FPLNNP-09-0725

Re: FPL Turkey Point Units 6 & 7 Project
Request for Additional Information
Air Permit Application and Prevention of Significant Deterioration Analysis
Project No. 0250003-013-AC (PSD-FL-409)

Figure 2PSD-1-c
Time History of Salinity in Biscayne Bay near Turkey Point
Source: South Florida Water Management District, 2009.

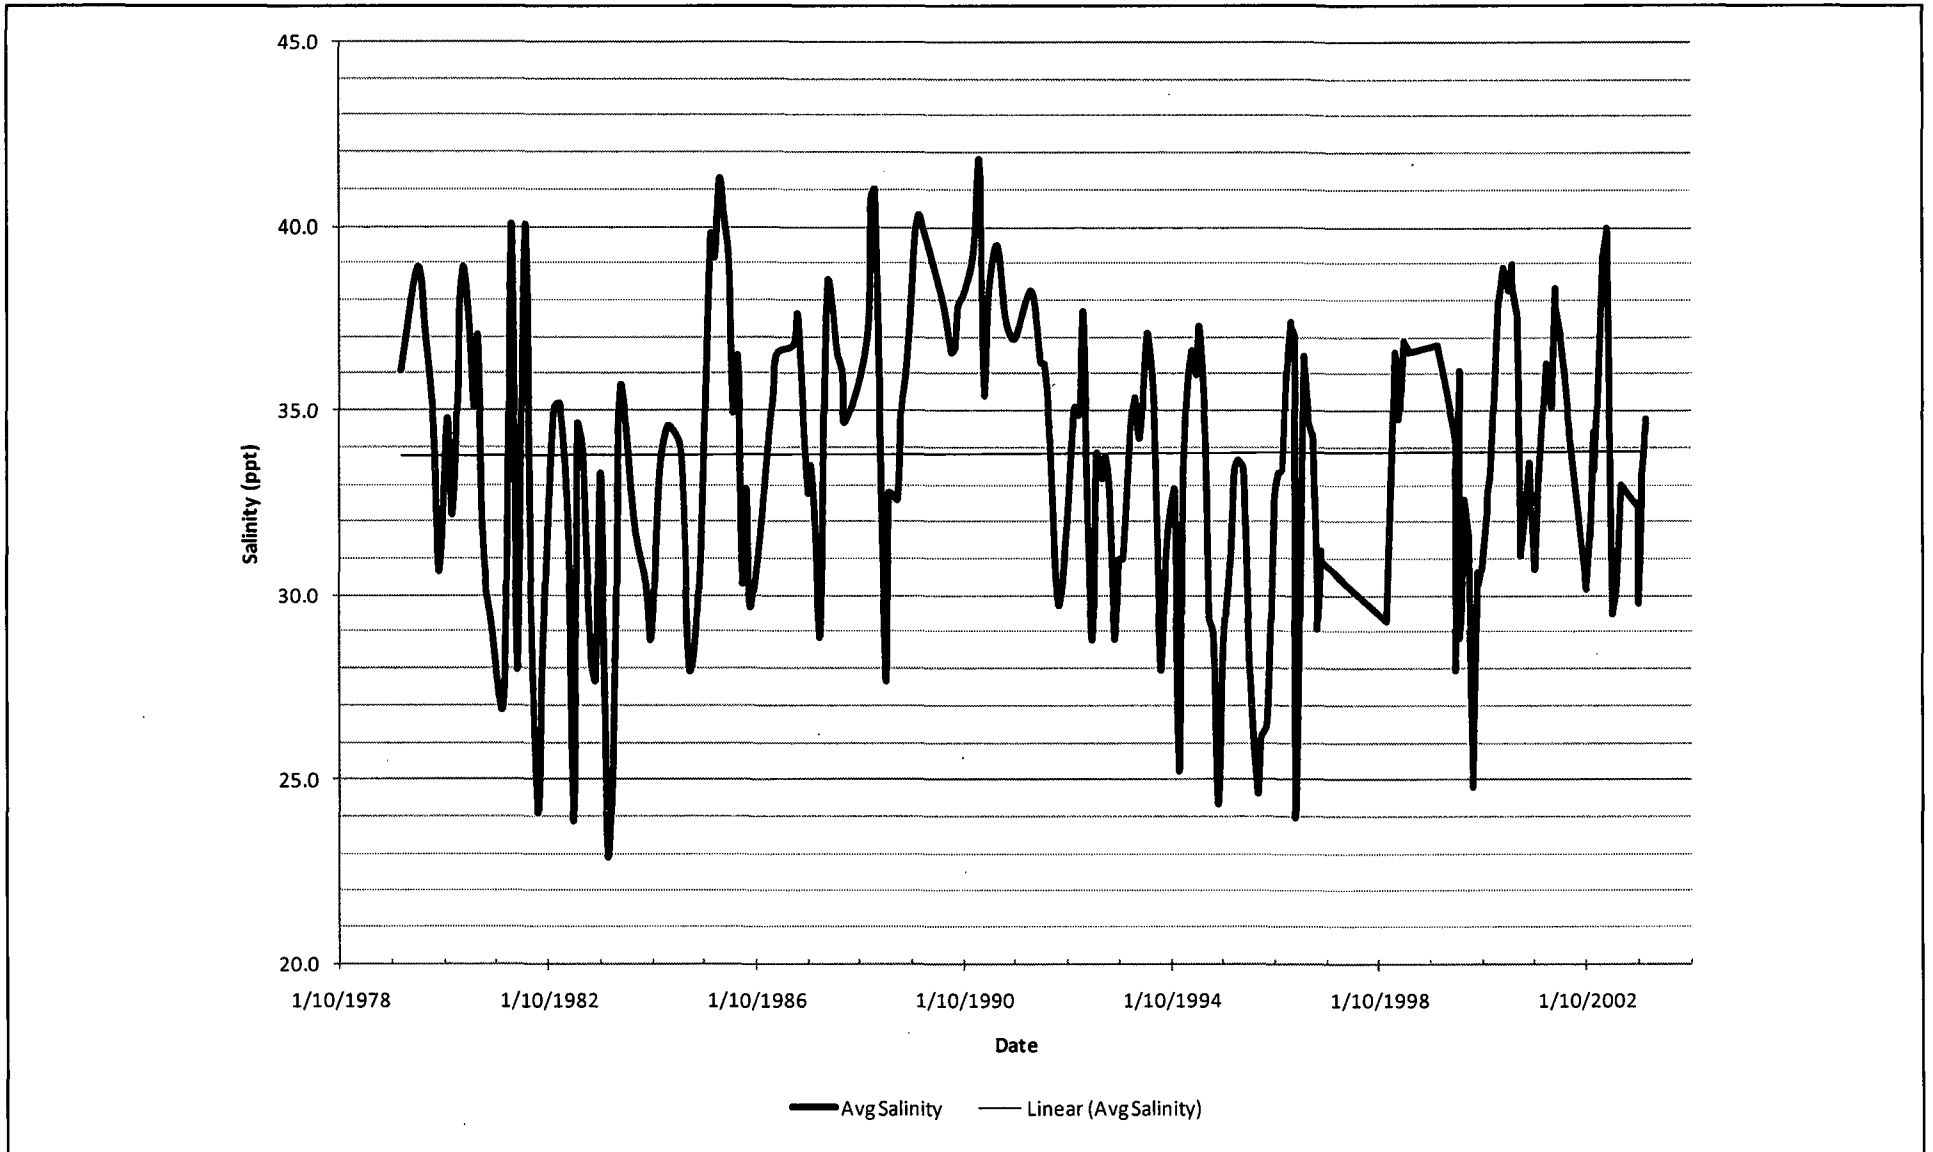
FDEP-2PSD-1-c The second source of water will be from radial collector wells, for which you estimate a maximum TDS concentration of 65,000 ppmw. In your response, you provided a representative analysis of the actual TDS for this source of water as 33,800 to 35,800 mg/L, which is approximately 33,800 to 35,800 ppmw. At this concentration, would the maximum total PM emissions from the cooling towers be reduced to approximately 518 tons/year?

Response: No, the total PM emissions would not be approximately 518 tons/year, since the TDS in the makeup water would be concentrated by 1.5 times to account for evaporation in the circulating water system cooling towers. At TDS concentrations of 33,800 and 35,800 ppmw (for saltwater used as makeup water to the cooling towers) the TDS concentrations in the circulating water would be 50,700 and 53,700 ppmw, respectively, when concentrated 1.5 times. The calculated annual PM emissions with this range of TDS concentrations are approximately 727 and 769 tons/year. The analyses provided in the response to FDEP-PSD-1-d for the first RAI show TDS concentrations of 33,800 and 35,800 ppmw for specific samples taken on the Turkey Point peninsula during aquifer pump tests.

The maximum estimated TDS concentration of 65,000 ppmw in the circulating water is based on the variability of TDS concentrations in Biscayne Bay and operation of the cooling towers. Although the water is withdrawn from 40 feet (ft) below Biscayne Bay via radial collector wells, the saltwater is expected to have TDS concentrations similar to those found in Biscayne Bay. The maximum TDS concentration of 65,000 ppmw for the circulating water is based on an upper bound of TDS concentration for saltwater of 43,333 ppmw from the radial collector wells, with 1.5 cycles of concentration.

Figure 2PSD-1-c shows the salinity in Biscayne Bay at a station near Turkey Point. Salinity is measured in parts per thousand (ppt) that approximates TDS concentrations in ppmw when multiplied by 1,000. The average salinity in Biscayne Bay near the Turkey Point peninsula is approximately 34 ppt or approximately 34,000 ppmw TDS. During wet periods, the salinity in the Bay is typically below average; during dry periods, the salinity in the Bay is typically above average. As shown in Figure 2PSD-1-c, the salinity can exceed 40,000 ppmw.
